MAINE TURNPIKE AUTHORITY

ADDENDUM NO. 1

CONTRACT 2026.02

PAVEMENT REHABILITATION AND
SAFETY IMPROVEMENTS
MM 27.4 TO MM 30.3

SHEET NUMBER:
18A OF 18

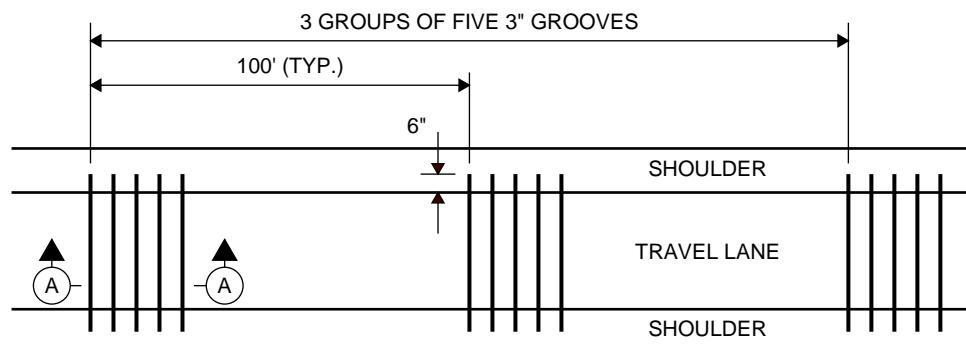
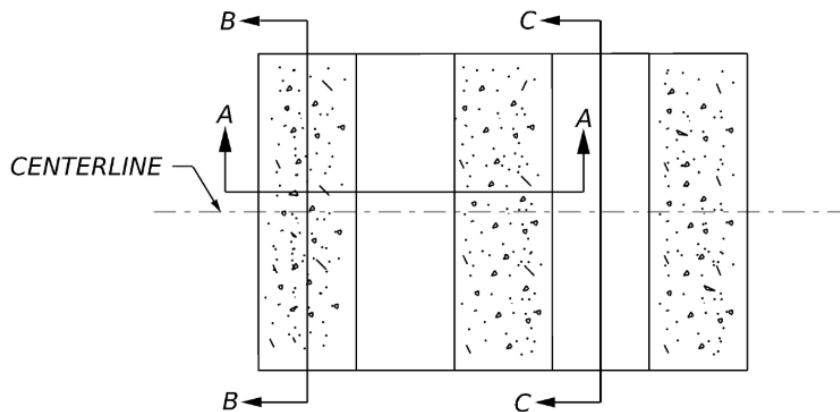
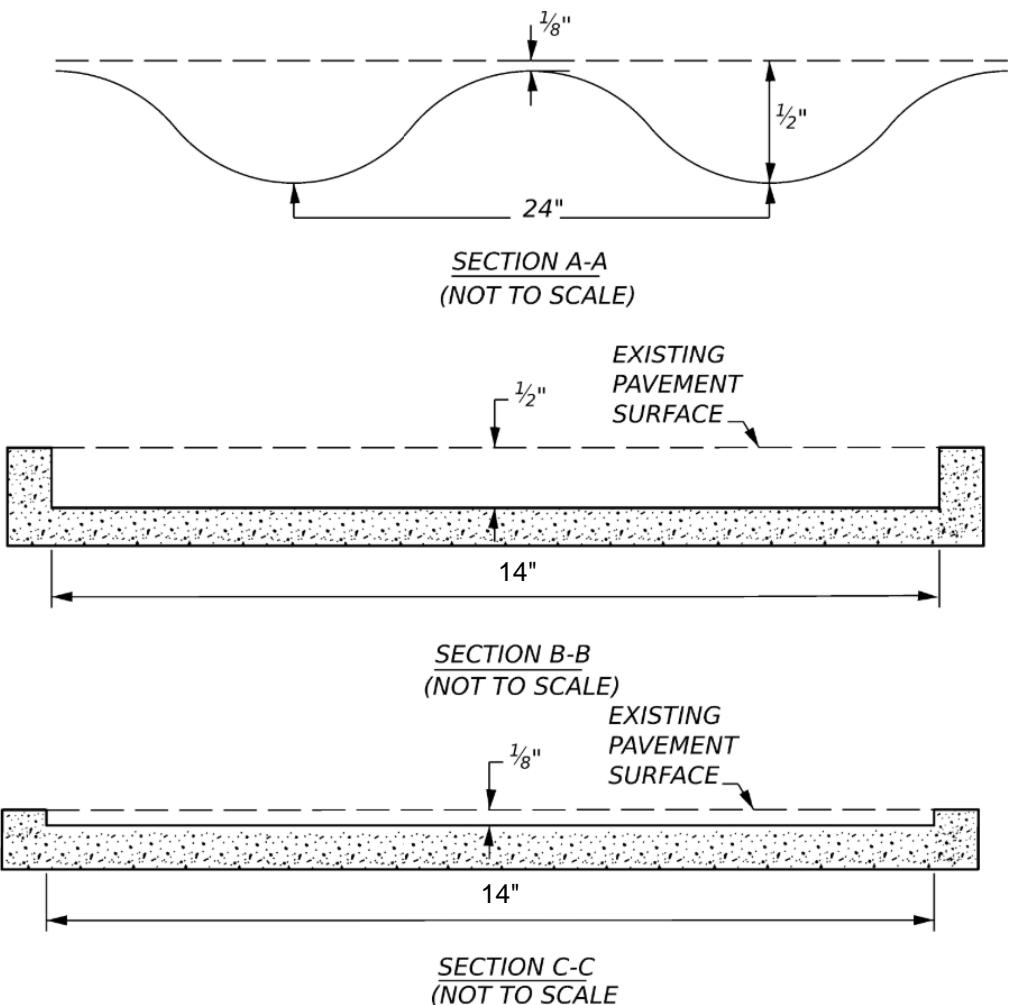
- Plan Sheet 2 Estimate Quantities & General Notes shall be replaced.
- Plan Sheets 18A-18C shall be amended to the plan set to show locations and details of Rumble Strips – Centerline and Grooved Pavement Strips at Exit 36.

This work shall consist of cutting a pattern of grooved pavement strips across the travel lane of the Exit 36 Southbound On Ramp at the locations shown on the plans.

The bituminous concrete pavement to be grooved, shall be accurately marked before beginning the cutting operation. The marking shall be in accordance with the locations shown on the Plans or as approved by the Resident.

The groove shall be cut with an approved power driven saw with an abrasive blade.
